Burlington Development Review Board

Tuesday, January 19th, 2021, 5:00 PM

TO: Development Review Board
FROM: Scott Gustin
DATE: January 19, 2021
RE: 21-0530CA; 60 Institute Road

To: Development Review Board
From: Ryan Morrison, Associate Planner
Date: January 19, 2021
RE: 21-0076CA/CU; 400 North Street

Site Plan
McKenna Property
400 North Street
Burlington, Vermont
KREBS & LANSING Consulting Engineers, Inc.
164 Main Street, Colchester, Vermont 05446

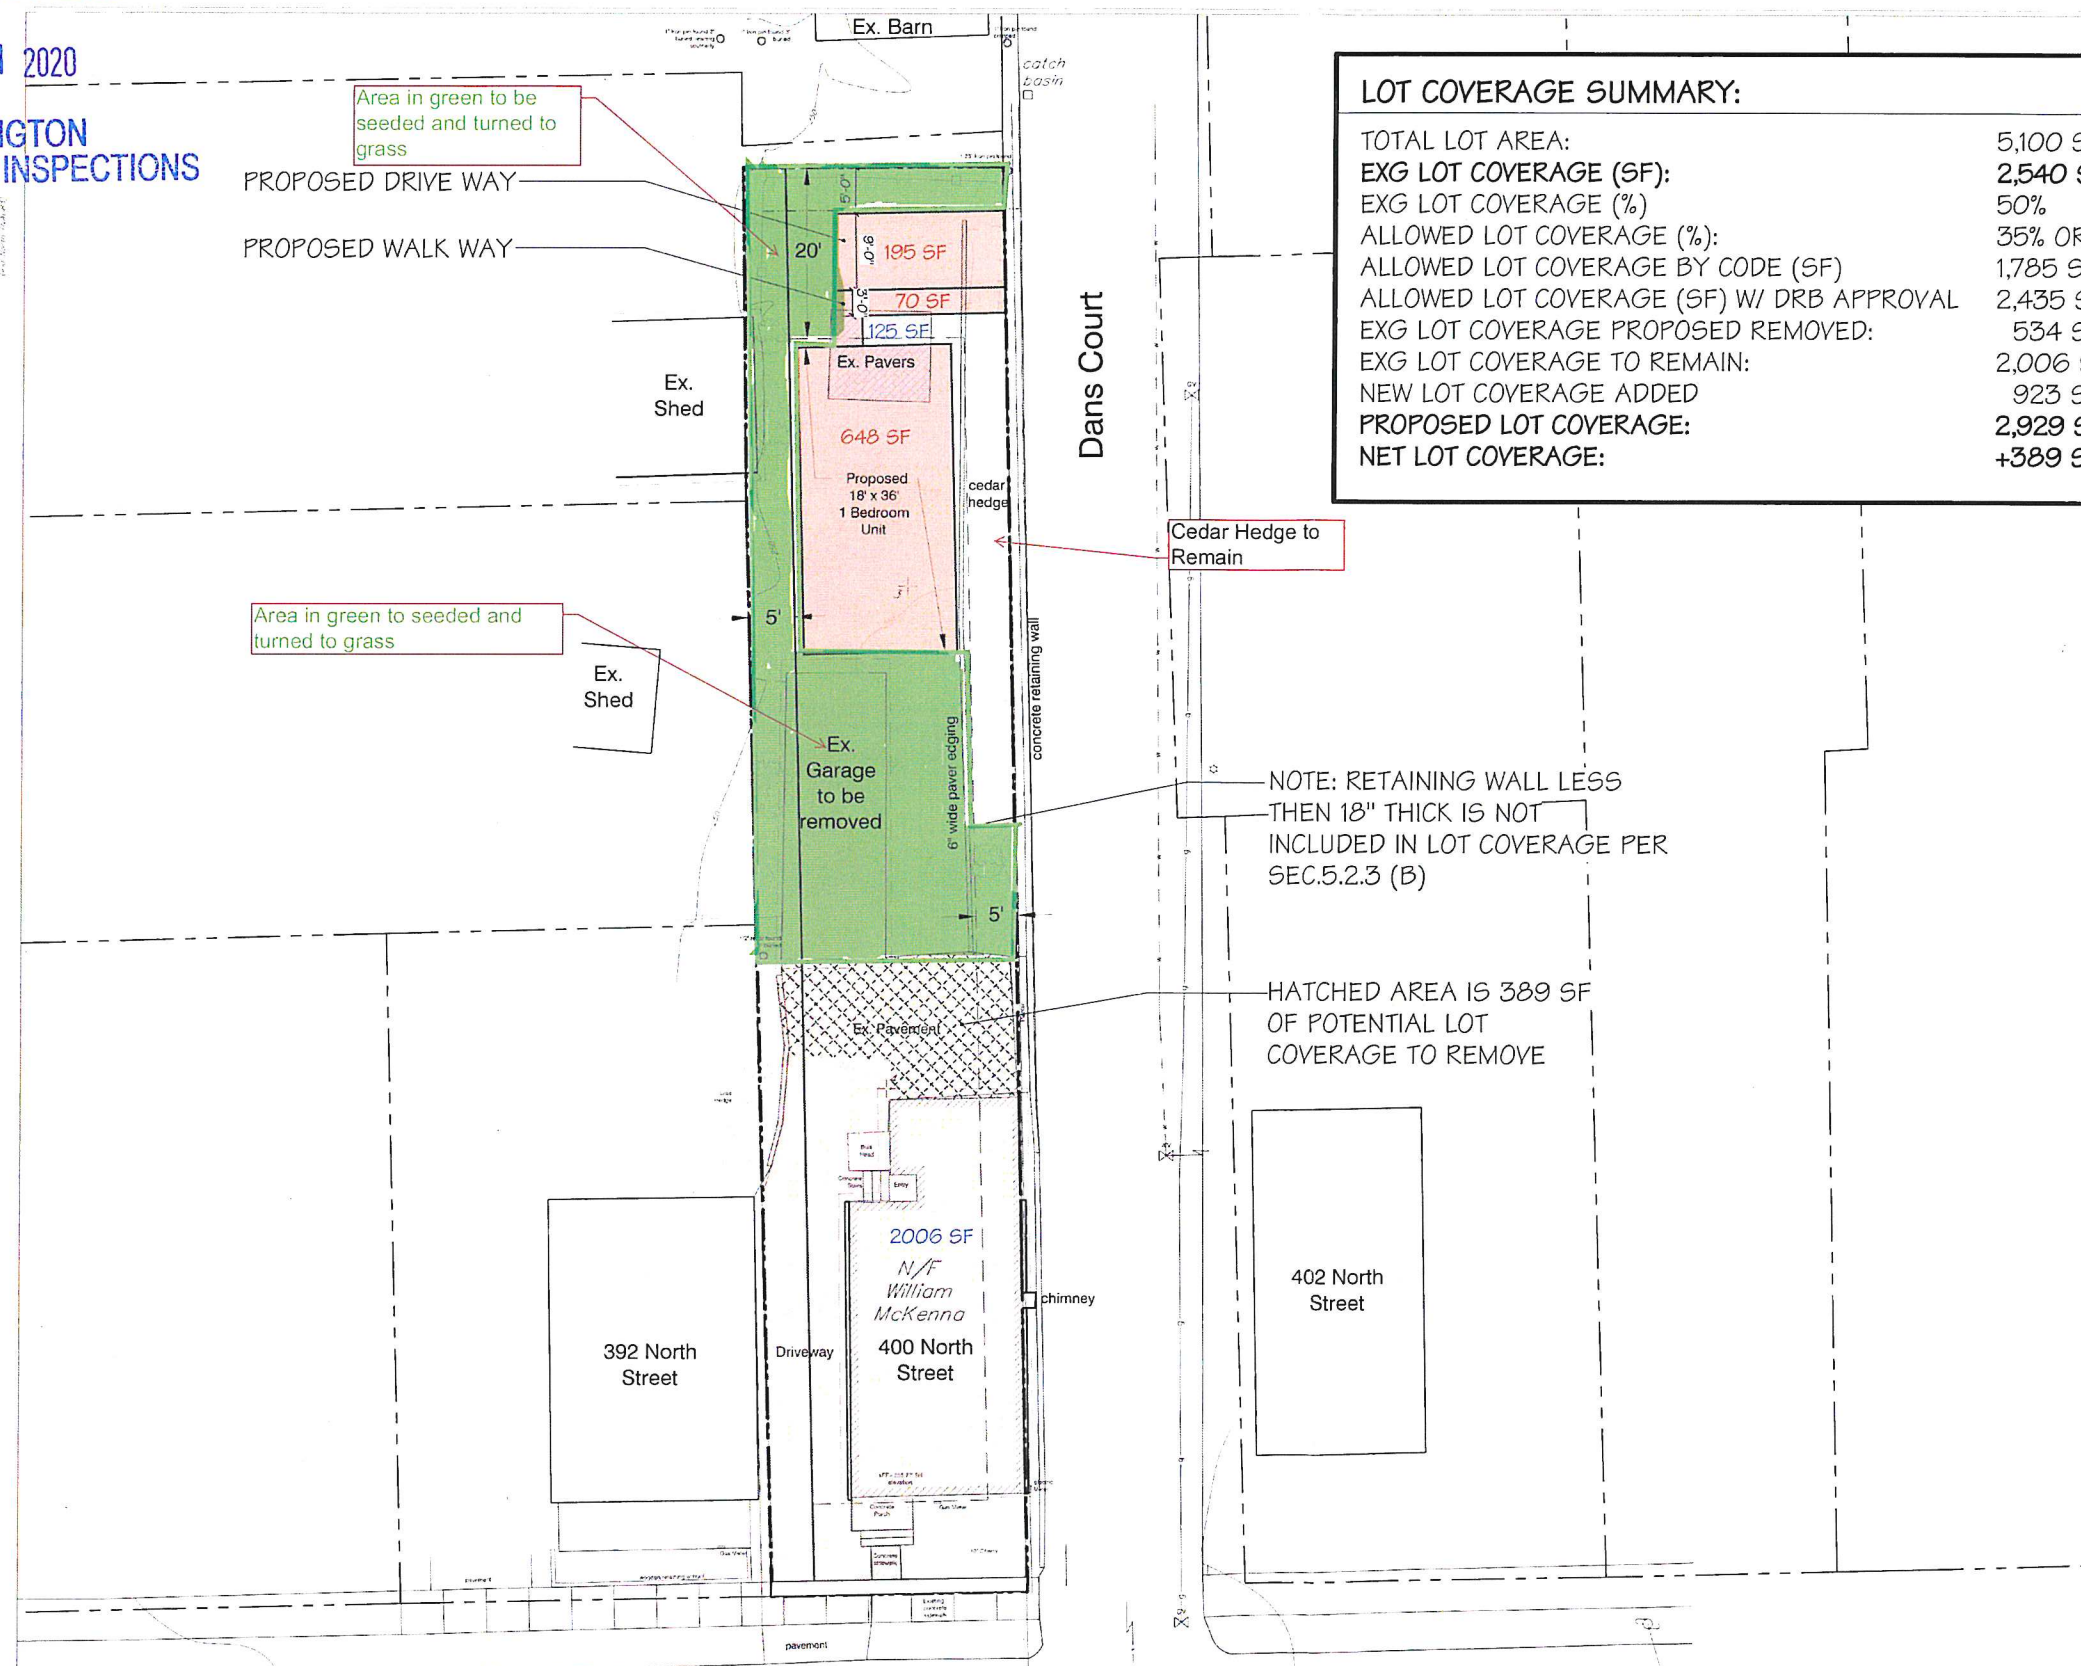
The RL zoning district limits lot coverage to 35%, plus a 10% bonus for features such as walkways, decks, patios, open porches, etc. Zoning Permit 99-504 documented existing and proposed lot coverage for the property at 51%. The submitted plans indicate an existing lot coverage of 50% (2,540 sf). The proposal involves removing 534 sf of existing lot coverage (garage, patio, and some driveway/parking area), while adding 923 sf of new lot coverage, for an end result of 2,929 sf. This results in an increase of 389 sf of new lot coverage for the ADU, which is less than the 650 sf allowed in instances of pre-existing nonconforming lot coverage.

The plans do not indicate any outdoor light fixtures and will need to. The applicant will have to revise the plans to show the location of all exterior light fixtures, and submit spec sheets for said light fixtures for staff review and approval. **Affirmative finding as conditioned**

The plans identify an electrical service box on the west elevation (street side) and a wall hung condensing unit on the east elevation. The cedar hedge that will remain will provide an adequate screen for the electrical service box. The plans will need to be updated to show any and all other outdoor mechanical units, mailboxes, trash/recycling bins, and any other new onsite utilities.

1. **Prior to release of the zoning permit**, the applicant shall secure a letter of adequate capacity from DPW for water and sewer services.
2. **Prior to the release of the zoning permit**, the applicant shall revise the plans to show the location of all exterior light fixtures, and submit spec sheets for said light fixtures for staff review and approval.

3. **Prior to the release of the zoning permit**, the plans shall be updated to show any and all other outdoor mechanical units, mailboxes, trash/recycling bins, and any other new onsite utilities.

17/12/2020 11:15 AM
S:\PROJECTS\2020\2020 North Beach Campground Laundry\Draw File\2020-Proposed Site Plan.dwg

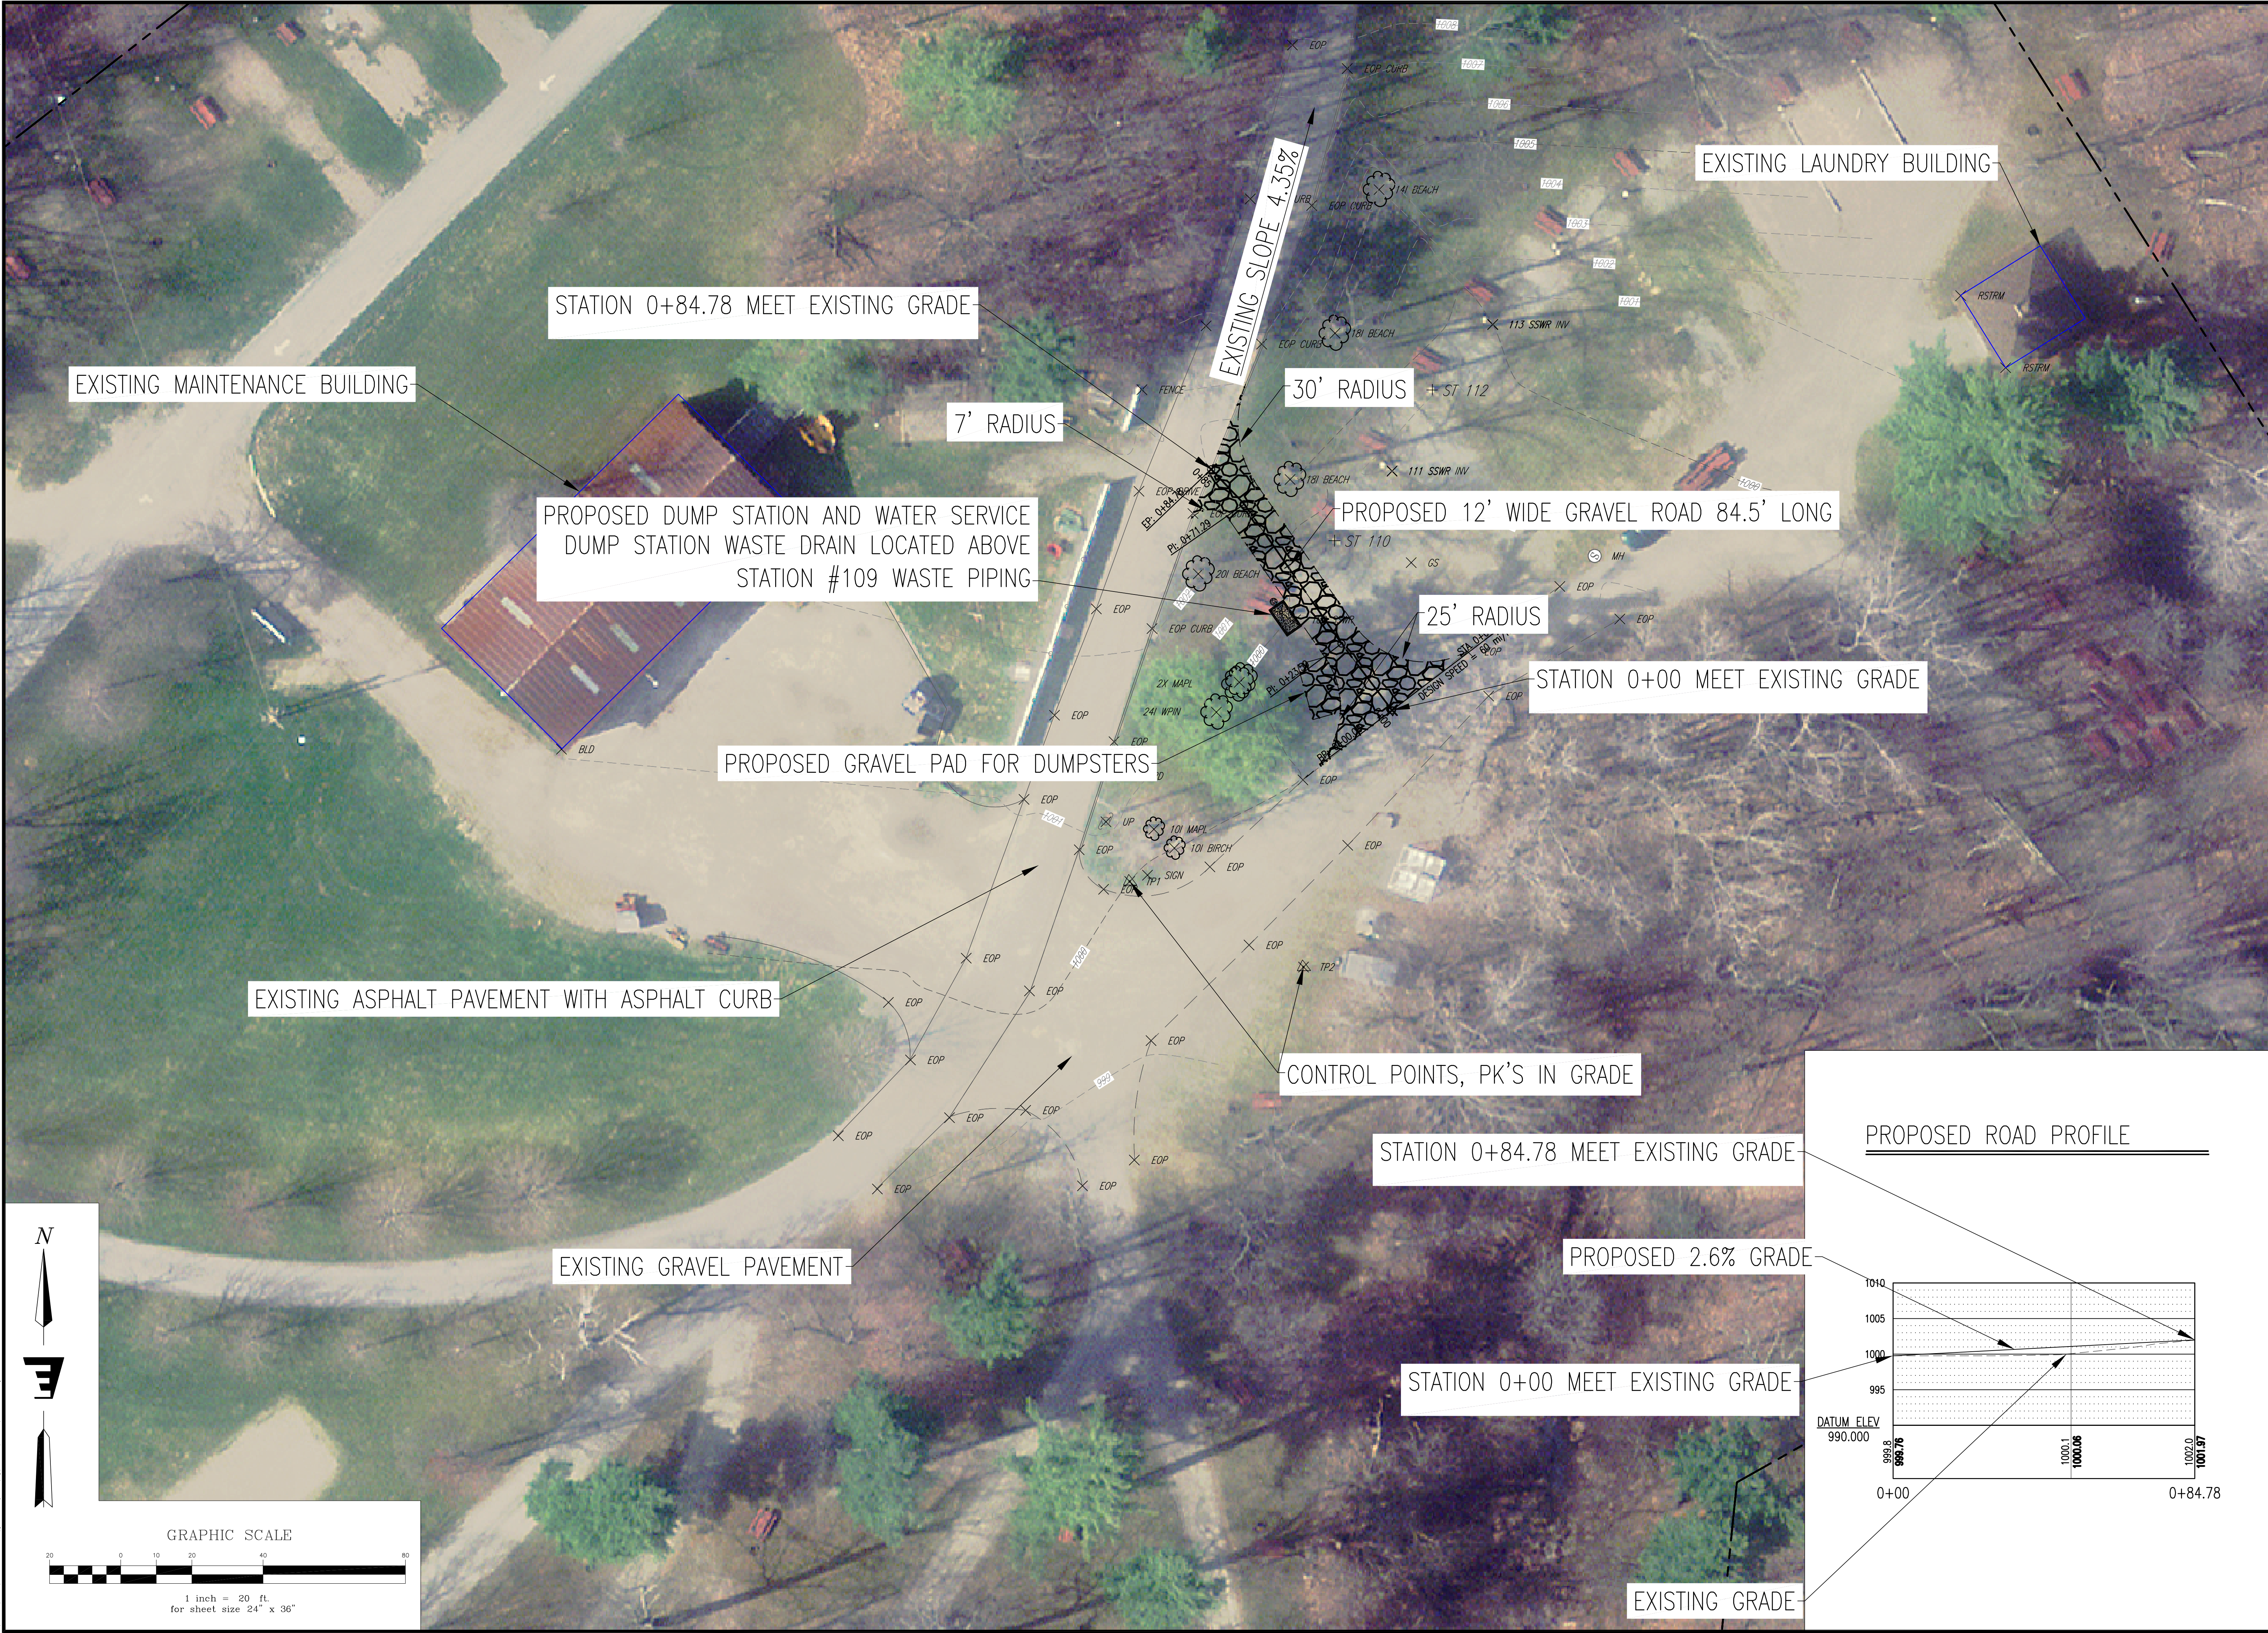
The proposed work is located far from all minimum setback requirements. No building height is affected. Lot coverage will be altered slightly. Up to 15% lot coverage is permissible, but no lot coverage information is noted on the site plan. Confirmation of acceptable lot coverage is required. **(Affirmative finding as conditioned)**

1. **Prior to release of the zoning permit**, revised plans shall be submitted subject to staff review and approval. Revisions shall depict:
 - a. Existing and proposed lot coverage area (square feet and percentage); and,
 - b. Dumpster screening details (stockade fence or similar).
2. **Prior to release of the zoning permit**, written approval of erosion control plan shall be obtained from the Stormwater Administrator.
3. The Applicant/Property Owner is responsible for obtaining all necessary Zoning Permits and Building Permits through the Department of Permitting & Inspections as well as other permit(s) as may be required.
4. Standard permit conditions 1-15.
